SERVICE BULLETIN

SUBJECT: ALTERNATOR WHINE, TR-7600/7625

DATE July 9, 1979

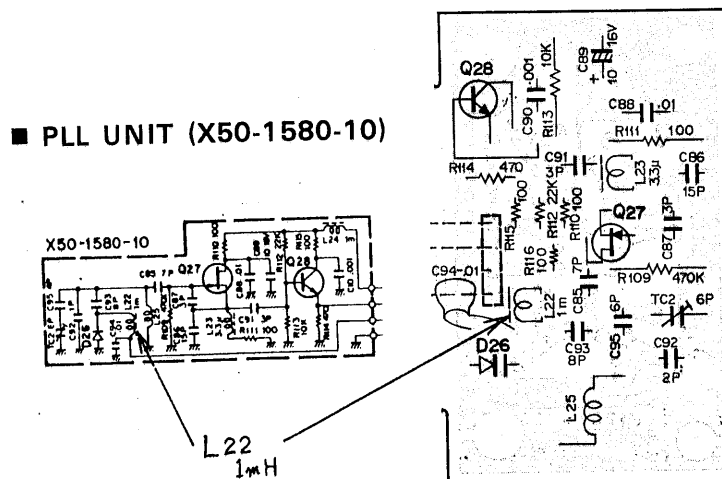
In some mobile installations, alternator whine may be heard during transmit. External B+ filtering does not have sufficient effect.

In some instances, using the cigarette lighter will cause this problem. Running off the fuse block, and even directly from the battery may still not eliminate the noise.

If all of these measures fail, replace L22 on the VCO unit X50-1580-10 from the original green coil, to either an orange or black coil. No adjustments should be necessary.

Old part number L40-1021-03 1mH
New Part number L40-1021-43 1mH
